Midland Independent Design and Construction Verification Program

Structural Evaluation of the Diesel Generator Building

Re: Docket Nos. 50-329 OM, OL and 50-330 CM, OL
Midland Nuclear Plant - Units 1 and 2
Independent Design and Construction Verification (IDCV) Program
Structural Evaluation of the Diesel Generator Building -
Assessment of the Structural Performance Capability as
Potentially Affected by Settlement Induced Cracking

TITLE Structural Evaluation of the Diesel Generator Bldg.CONT. ID. NO. 3201-001-031PROJECT: CONSUMERS POWER COMPANY MIDLAND IDCVPNO. OF SHTS. 42

FIGURE 6-2
DIESEL GENERATOR BUILDING
SETTLEMENT MARKER LOCATIONS

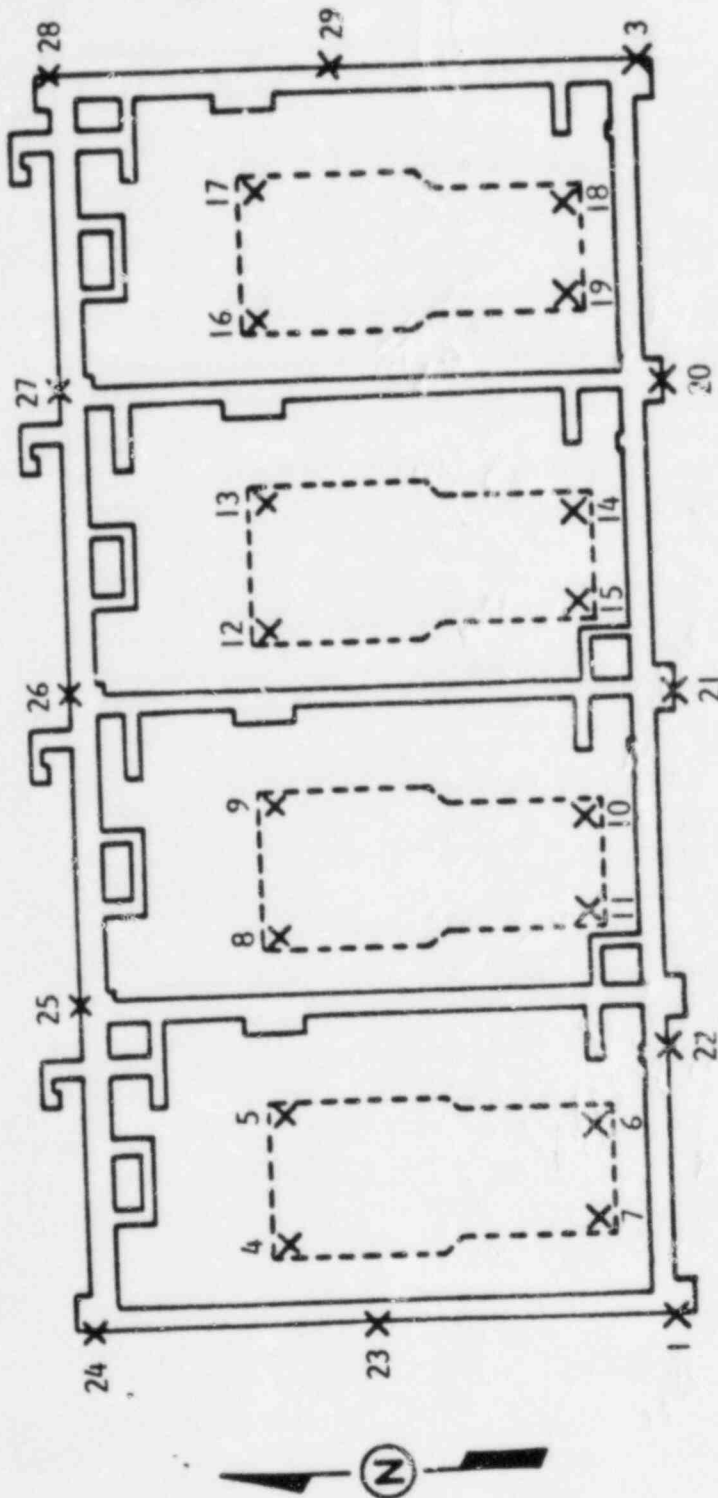
The building settlements have been monitored at close intervals during the construction period and thereafter. Figure 6-2 presents the location of the settlement markers indicating where survey measurements are taken. The data spans over a period of 5 years with measurements taken approximately every other week. This large amount of data allows one to follow the settlement history through the stages of construction, duct bank isolation, surcharge period, dewatering, and up through the present. It also provides a means of assessing potential random and systematic errors in the measurements. The Midland project has concluded that significant errors exist in the measurements due to a variety of circumstances. A study of these data is presented in the following section.

FIGURE 6-3
DIESEL GENERATOR BUILDING
SOUTH WALL
SETTLEMENT INCREMENT

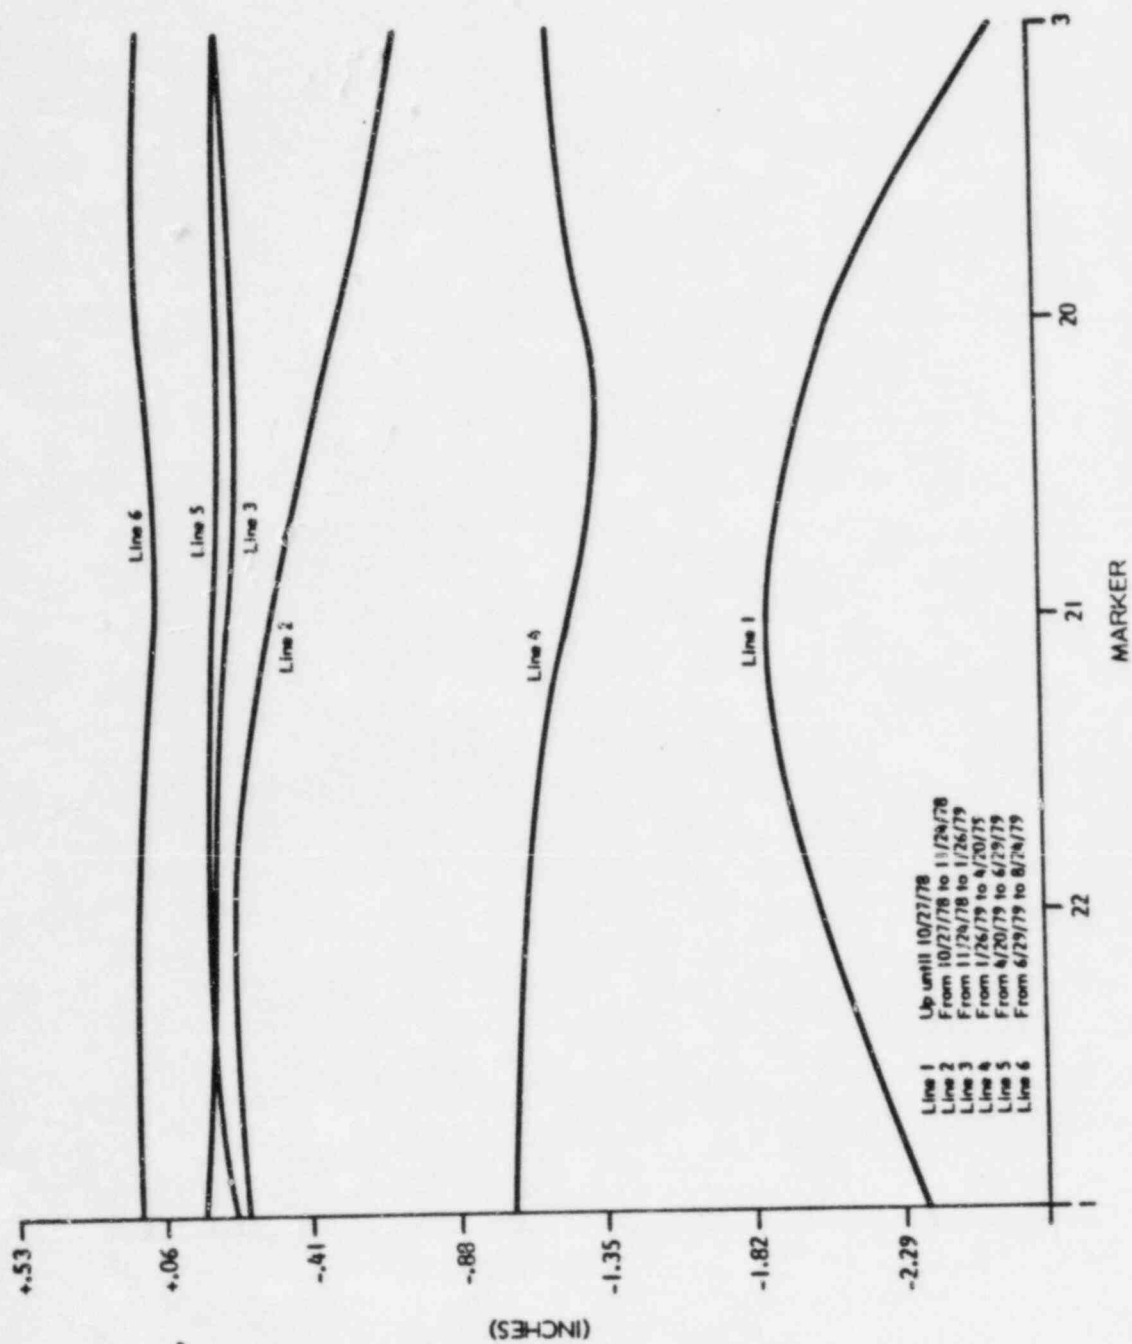
Figure 6-3 shows the incremental settlement for 6 time periods between July 1978 and August 1979 for the south wall of the DGB. The first three measurements show large differential deformations and introduction of curvature in the wall. The latter ones show stabilization of differential settlements implying that the wall is still settling but as a rigid unit, introducing little additional in-plane bending. For more recent recordings the stabilizing trend is even more noticeable. Study of the foundation curvature variation and deformation of the building with respect to its rigid body motion point toward the same trend. This is supported by an evaluation discussed in reference 4, where it was noted that the settlements occurring during the time periods represented by lines c and d (reference 4, figure DGB-7), were those that are expected of a rigid body. In figure DGB-7, line c represents settlement during the surcharging period (1/79 - 8/79) and line d represents estimated settlement during the post-surge period (9/79 - 12/2025). The point here is that the early cracking occurred when the building was only partially completed. Upon completion, the five sided (four walls and a roof) structure is now responding as a stiffer, essentially rigid body as would be expected.

Hence during its construction stage, the building underwent substantial differential settlement that introduced in-plane curvature in the walls with resulting stress and cracking compounded with normal shrinkage cracking. As the building was completed and the concrete aged, it tended to behave more and more as a rigid unit, the whole foundation (or building) moving as a plane (or a unit). The recent data indicates that for the last four years the building has generally settled as a rigid body introducing relatively little additional distortion in the structure. We expect this behavior to persist in time.
